Development Management Delegated Decision Report B/17/0317/NMA4

SUMMARY OF APPLICATION	
Application Reference	B/17/0317/NMA4
Application Type	Non-material Amendments
Proposal	Application under S.96A for a non-material amendment to approval B/17/0317 to allow the omission of the stone heads above the first floor windows on the house type 912
Location	Heron Park, Wyberton Low Road, Boston, PE21 7SQ
Applicant:	Mr William Nuttall, Chestnut Homes Limited
Agent:	
Target Decision Date:	n/a
Statutory Expiry Date:	13-Jan-2021
Extension of Time:	n/a
Recommendation	APPROVE
Report by:	Trevor Thompson
Date:	29 th December 2020

The approved plan is 'type 912-02 **rev A** which is shown below.

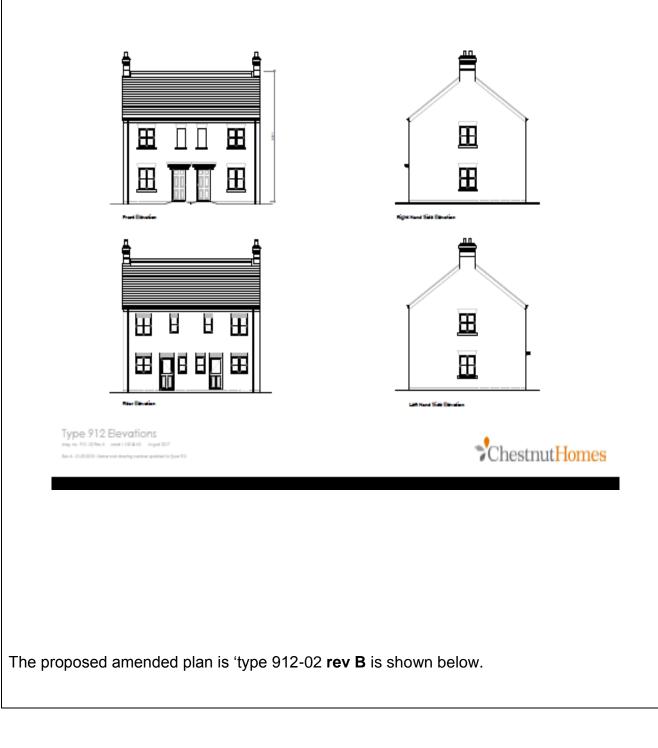
Omission of the stone heads above the first floor windows on the house type 912 - affecting plots 54, 55, 62, 63, 66, 67, 68, 69, 70 & 71

The omission of the stone heads above the first floor windows on the house type 912 is a very minor alteration and will not undermine the design quality of this scheme.

It is therefore recommended that condition 2 is amended (as shown in bold below) and changes the approved plan relating to dwelling type 912 from revision A to revision B.
